Re: Atlantic Coast Pipeline, LLC  
Docket Nos. CP15-554-000 and CP15-554-001

**VIRGINIA CAVE BOARD COMMENTS ON THE PROPOSED ATLANTIC COAST PIPELINE  
DRAFT ENVIRONMENTAL IMPACT STATEMENT (ROUTE VERSION 11b)**

Figure 1: Proposed Dominion Atlantic Coast Pipeline route 11b and karst near the Burnsville Cove, Virginia.

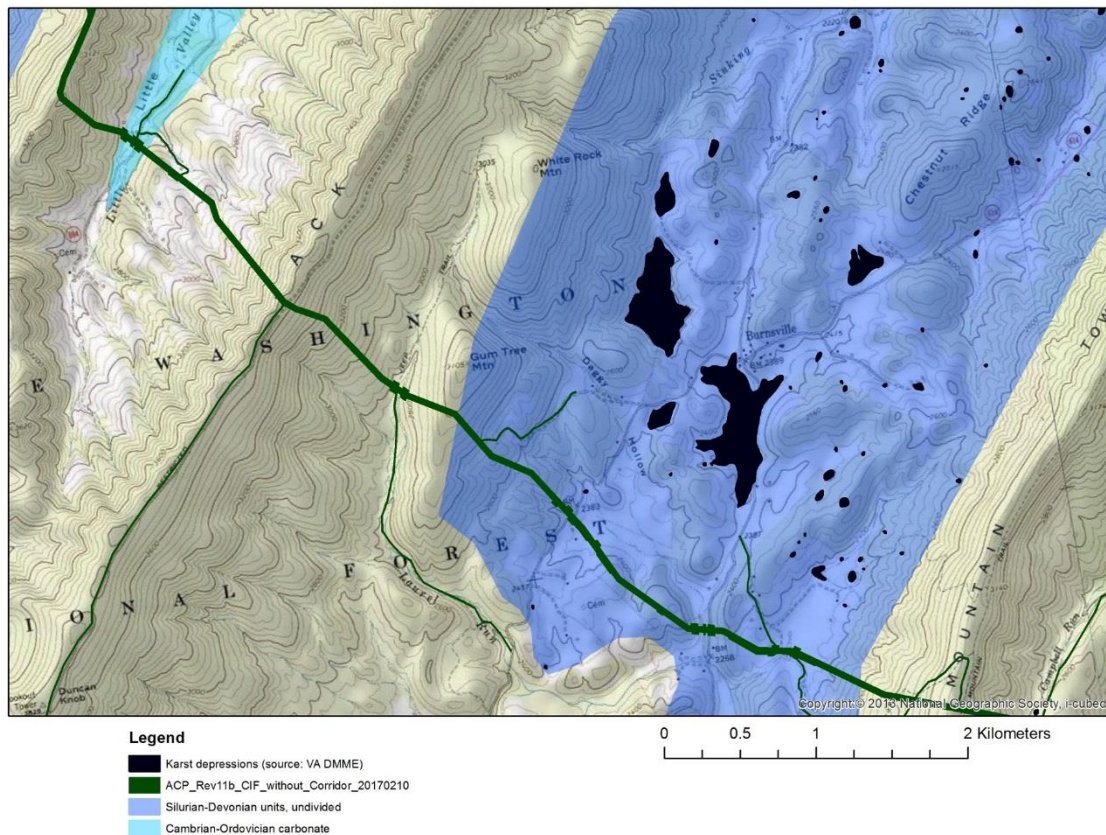
Foremost among our concerns is that the newly proposed pipeline route version 11b crosses one of the most significant karst regions of the Commonwealth of Virginia, the Burnsville Cove (**Fig. 1**). This is a result of the revision of the ACP route that had been proposed in 2015. The Cave Board has not yet commented on the revised route version 11b, and is providing that commentary herein.

The Burnsville Cove is an approximately 18 square-mile area straddling the Highland-Bath county line near the town of Burnsville, Virginia, part of which is highlighted in **Fig. 1**. The Burnsville Cove contains 97 known caves (White, 2015) which contain over 80 miles of surveyed passageways (VSS, 2016). Two of the caves have been declared National Natural Landmarks by the United States Department of the Interior, National Park Service; 14 of the caves are listed as Significant by the Virginia Speleological Survey and the Virginia Cave Board.

The Virginia Cave Board is concerned that the ACP construction and operation in the headwater regions of the Burnsville Cove, and along the proposed access roads may have negative environmental impacts on this significant karst area. The cove is characterized by a complex karst drainage system such that under normal flow conditions all surface water sinks into the karst bedrock, and is eventually discharged through four springs along the Bullpasture River—a stocked trout stream—at the northeast end of the cove. The recharge areas of these springs have been determined by 27 dye traces from sinking points connected to these springs by subsurface flows (Davis, 2015).

Specifically, a dye trace on March 26, 1971 from a sink point along Daggy Hollow Run demonstrated a connection to Cathedral Spring, located 7.6 km to the northeast from the sink point; the transit time of the dye was less than 15 days (Davis, 2015). This and other traces within the Burnsville Cove region illustrate the complex and intimate connection between surface runoff and groundwater in this significant karst region.

Therefore, we strongly recommend complete avoidance of areas along the proposed ACP route where surface flows within—and runoff of sediment from—the zone of pipeline construction and access roads will adversely impact high risk karst features within or inferred to receive drainage from the pipeline construction corridor and access roads. These impacts can only truly be determined through tracer tests.

Figure 2: Map showing the ACP route 11b where it crosses Valley Center, Virginia. Note the locations of Dever Spring, and the dye trace vectors indicating subsurface flow connecting the spring and surface swallets. The Smith Fish Pond that lost water in November 2004 is also shown.

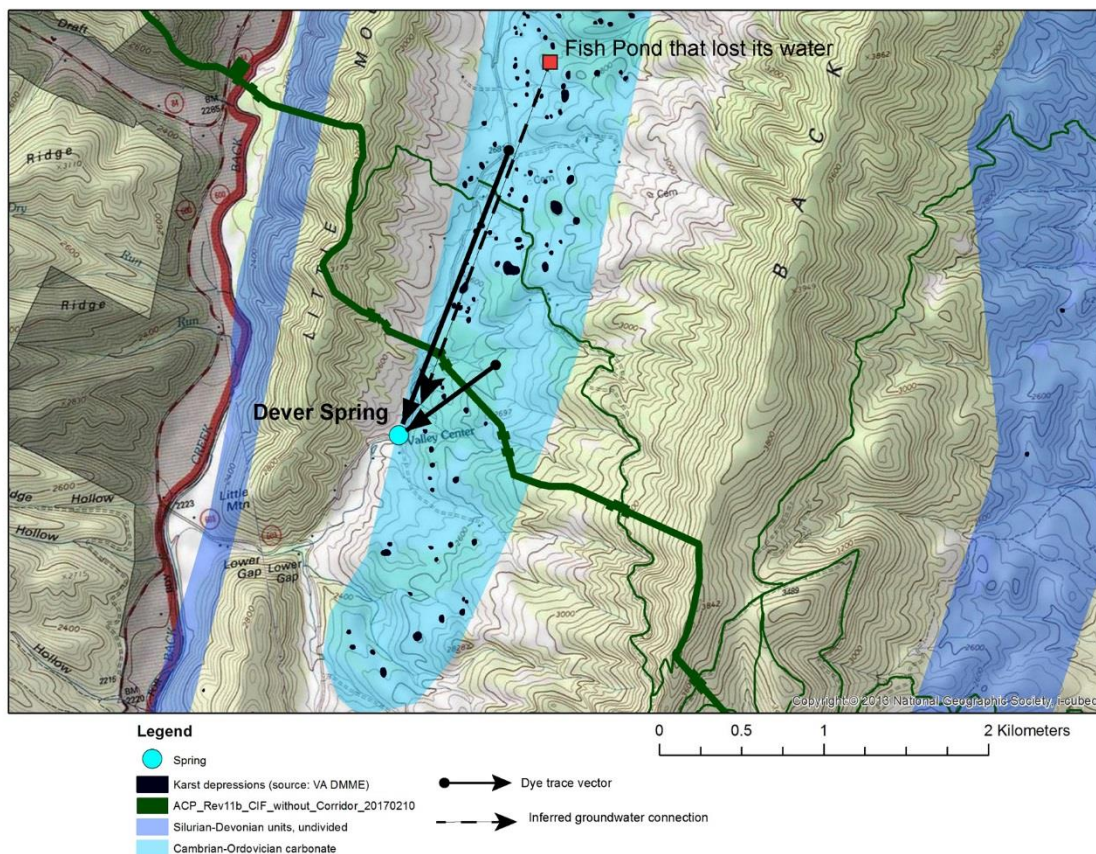
We further note that the ACP route revision 11b crosses a belt of karst at Valley Center, Virginia (**Fig. 2**), which is an area where the karst drainage is only partly understood. Specifically, in November 2004, the Smith Fish Pond (SH6119) just northeast of Valley Center lost its water and fish, and Dever Spring (located a mile and a half to the southwest), then ran muddy for a week (J. Brock, pers. comm. to R.A. Lambert, December 2004). As a

result, the Virginia Department of Conservation and Recreation Natural Heritage Program (DCR-DNH) conducted multiple dye traces in the Valley Center/Mill Gap areas in an attempt to delineate the Dever Spring recharge area. The positive traces indicate flow that would cross the proposed ACP route 11b (Fig.2). Moreover, the karst assessment survey conducted by GeoConcepts Engineering, Inc. (FERC Accession Number 20170224-5149) indicates a greater concentration of karst depressions and caves than previously known (Fig. 3), many of which are directly intersected by the proposed ACP route version 11b (Fig. 4).

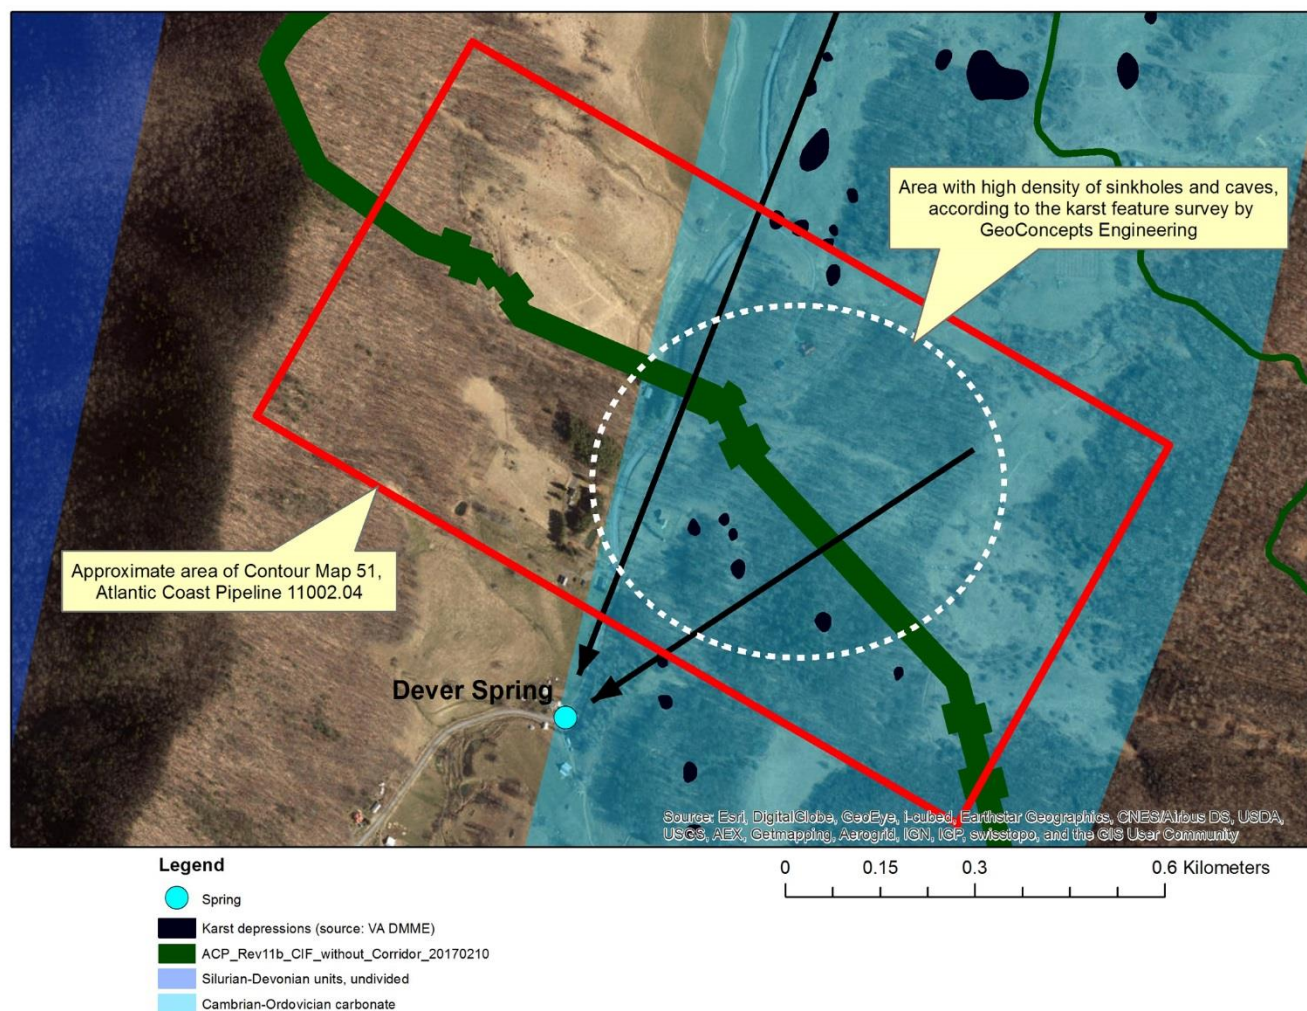
Unfortunately, dye traces by DCR-DNH were curtailed before the resurgences of all the known sinking points within the suspected recharge area for Dever Spring were definitively determined. Nonetheless, knowing that the water from the Smith Fish Pond went south to Dever Spring, and that a later dye trace confirmed flow to south across the proposed ACP route version 11b (see **Fig. 2**), we infer that pipeline construction may adversely impact Dever Spring. Trenching a few hundred feet north of Dever Spring within a zone of high karst feature density will potentially result in underground passageways carrying water and sediment recharged from the surface karst features to the spring. Disturbance of karst features through this area should be avoided.
